CITIZENS COMMITTEE TO COMPLETE THE REFUGE

September 22, 2025

RE: Comments in Response to the Notice of Preparation of an Environmental Impact Report for the Redwood Life Precise Plan, August 22, 2025

Modified excerpt from Sheet L3.01, *Site Sections*, showing horizontal location of section 1 (left), and the vertical section with two trails (right).

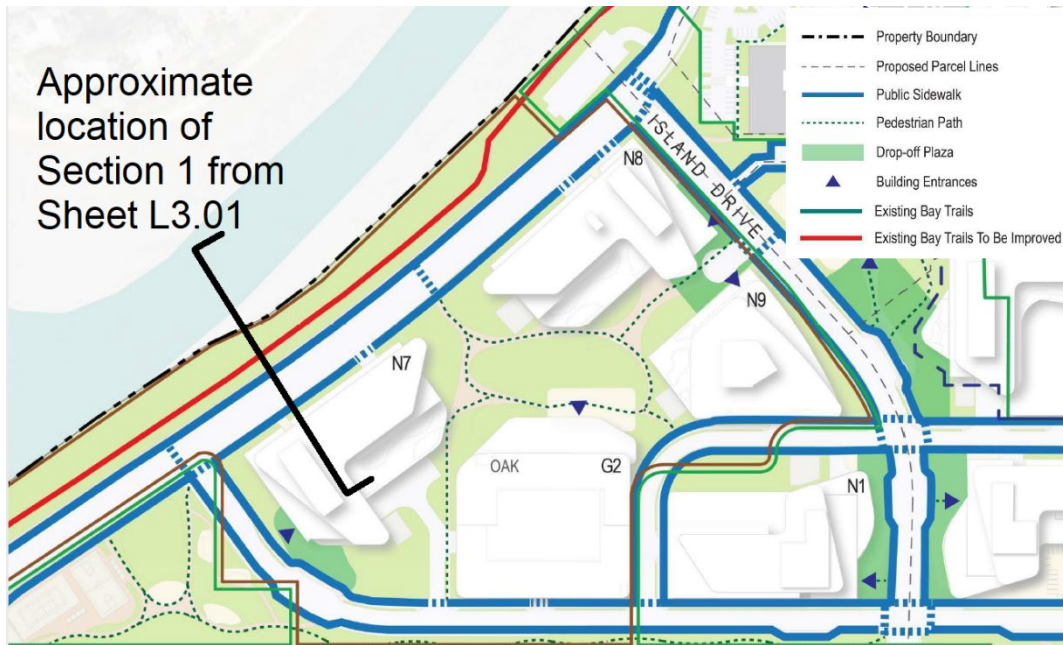
It appears that there is inconsistent information in the Plan Update regarding the Belmont Slough shoreline. Illustrations on Sheet L3.01, *Site Sections*, show two pedestrian trails: the existing Bay Trail and a new trail atop a proposed new levee, while Sheet L6.04, *Pedestrian Circulation Phase 4*, only shows an improved Bay Trail and no new levee with a trail on top:

In order to analyze potential impacts to habitat and wildlife along Belmont Slough, a stable project description must be provided. An accurate location of the proposed new levee and trail improvements needs to be provided, and described in a clear and consistent manner in all project documents and throughout the DEIR. Detailed information on the design, dimensions and construction of the levee and Bay Trail must be provided in the DEIR, as they are missing from project plan documents.
